STATE OF IDAHO
DEPARTMENT OF
ENVIRONMENTAL QUALITY

Re: Ron Tillotson RV Park Water System Improvements – Well Site Evaluation for Proposed Water System Location, Bannock County
DEQ #03-08-24

WELL SITE INSPECTION FIELD SURVEY

MAP OF SOURCE VICINITY

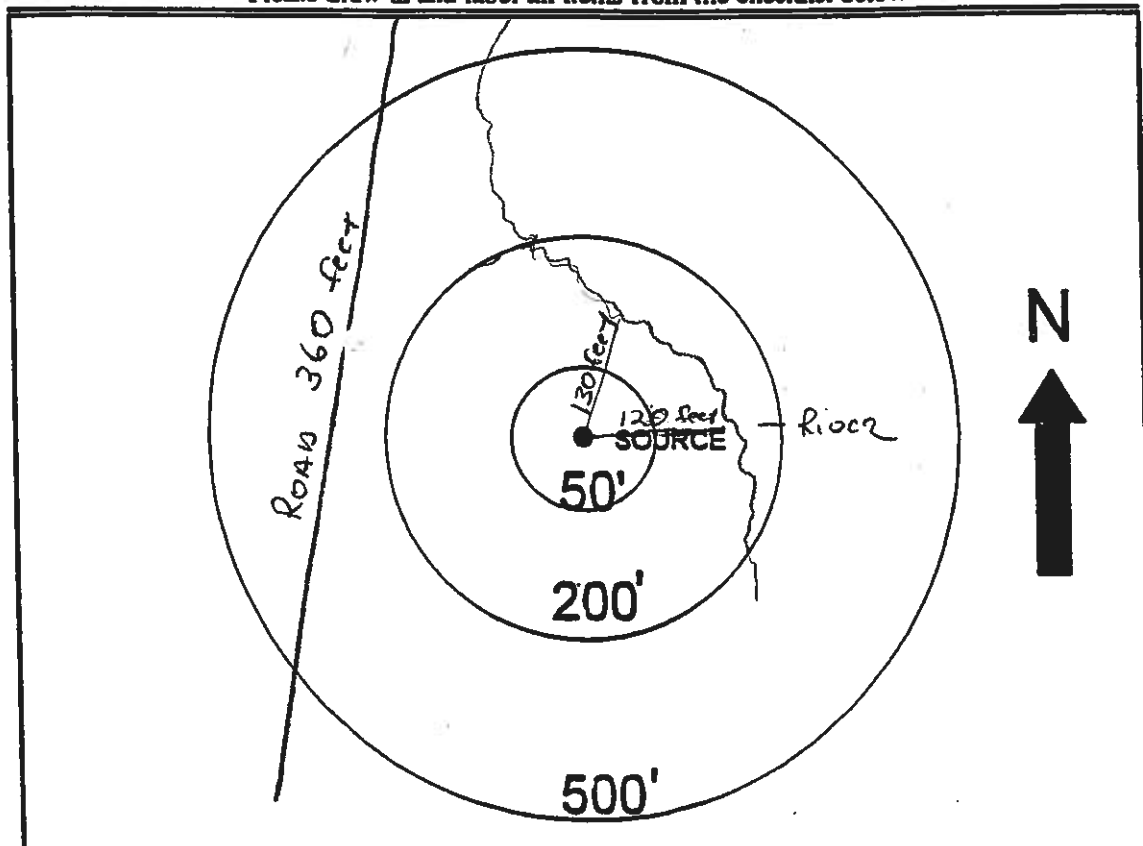
☒ Surface water within 500'☐ On-site sewage systems or lagoons within 500'☒ Municipal or on-site sewer lines within 200'☒ Dairies or livestock feeding operations within 500'☒ Stormwater disposal systems within 500'☒ Injection Wells within 500'☐ Other sources of contamination within 500'

42.37' 38.692 N
 111.59' 45.391 W

5,108 feet ELEVATION
